**Recall Campaign 10V-254: Replace Safety Belt and Modify Sound Insulation**

E82, E88 (1 Series)

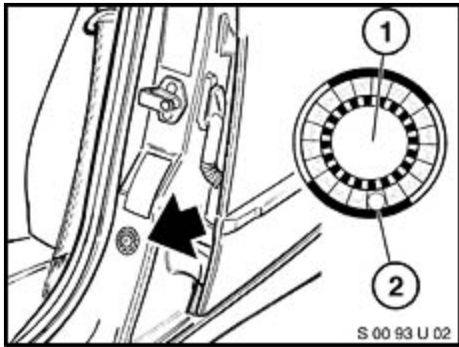
This Recall has been assigned code number **565**. After the vehicle has been checked and/or corrected, obtain a label (SD 92-380) and:

- A. Emboss your BMW center warranty number in the middle of the label (1);
- B. Punch out code number **565** (2), printed on the

label; and

- C. Affix the label to the **B**-pillar as shown.
